City of Excelsior
Notice of Special Meeting
of the Excelsior Heritage Preservation Commission

City of Excelsior
Special Meeting Agenda
Excelsior Heritage Preservation Commission

Minutes
Heritage Preservation Commission Meeting

Wood clad windows were permitted on all facades of the Landmark structure at 6 Third Street (historic windows were missing).

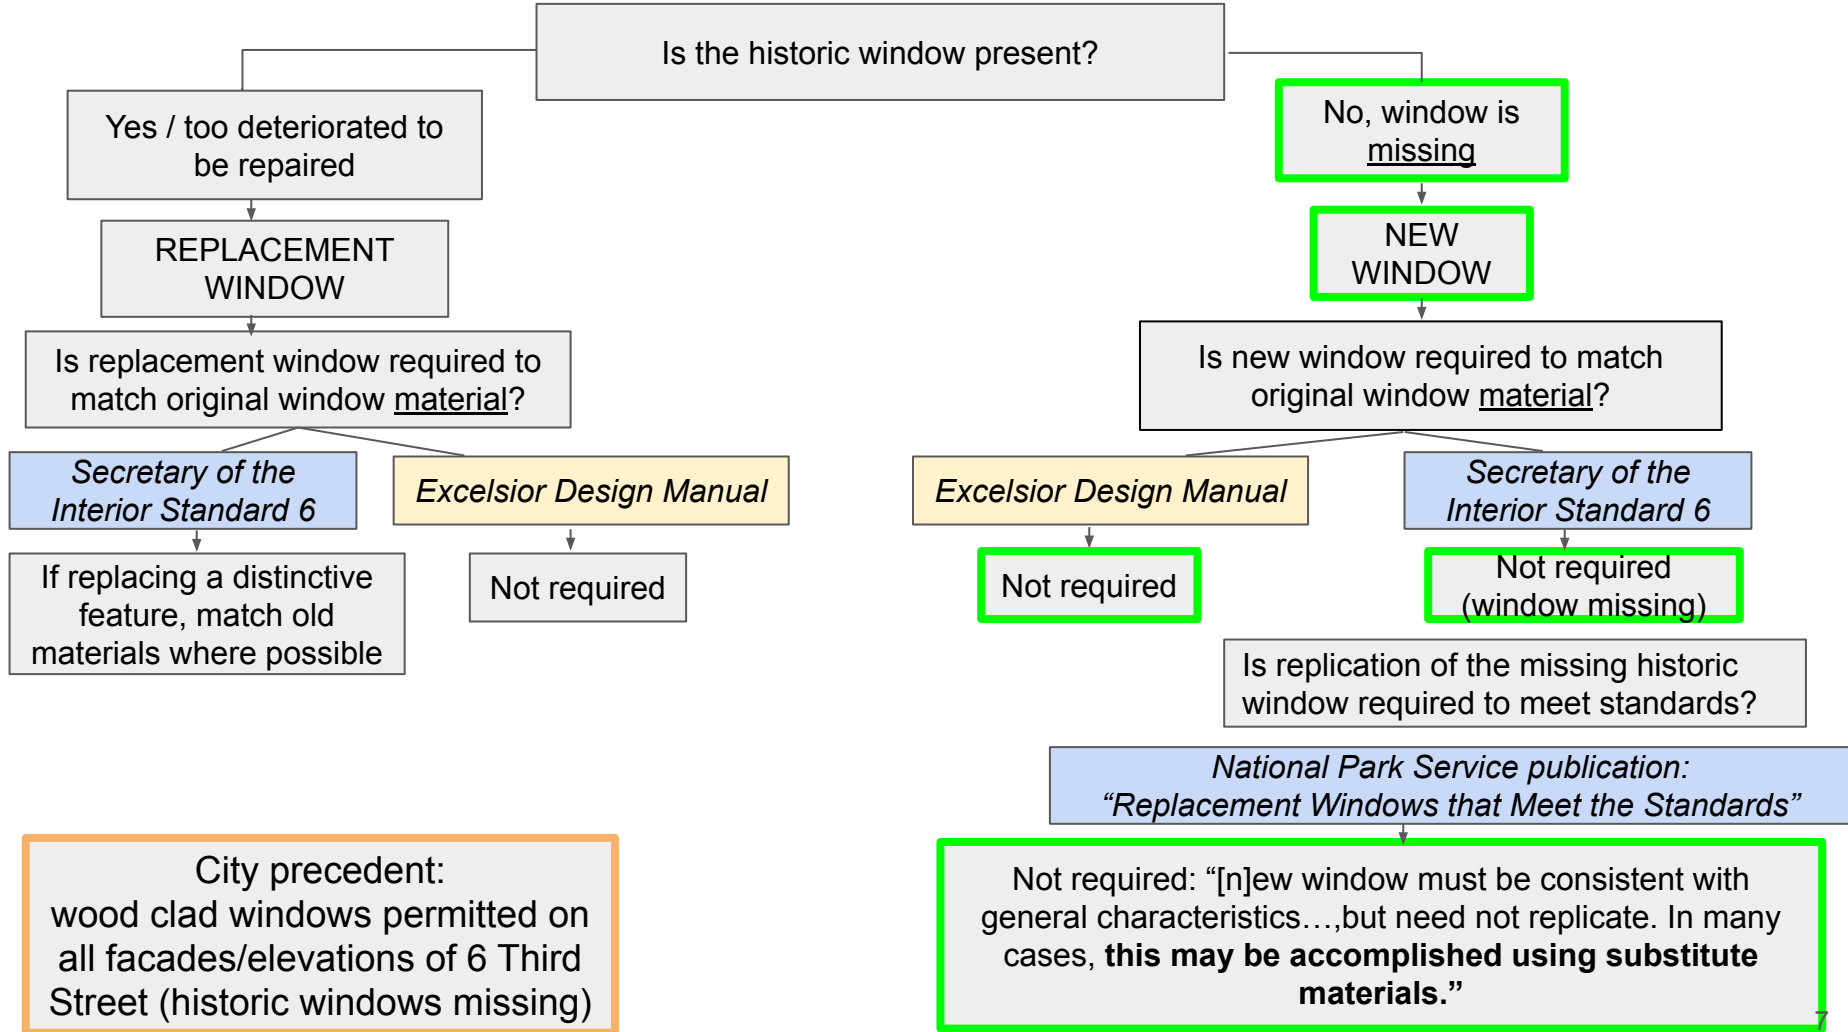
Condition 1: Precedent allows wood clad windows where original windows are missing

The city's past precedent likewise demonstrates that wood clad windows are permitted under the Guidelines in the context of new windows where historic windows are missing:

Recently approved addition to Landmark property with new design elements not historically present

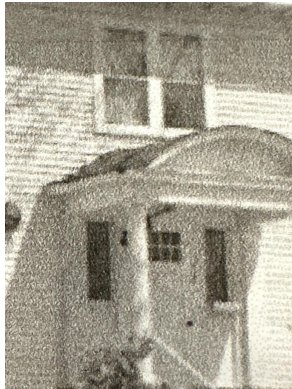
No false history. The risk of creating a false history is minimal, as the existing non-historic addition is clearly distinguishable from the original structure in height, soffit detailing, and size/pattern of window and door openings. Square divided lights are also frequently used in new, modern construction projects and are not exclusively associated with a narrowly defined period of years.

Proposed windows are on non-historic addition and located at the rear and far back corner of a secondary elevation of such addition. The proposed windows are minimally visible from the street and are located more than 80 feet from the front property line. Allowing the proposed divided lights on the non-historic addition in this minimally visible location will not damage the historic character of the home.
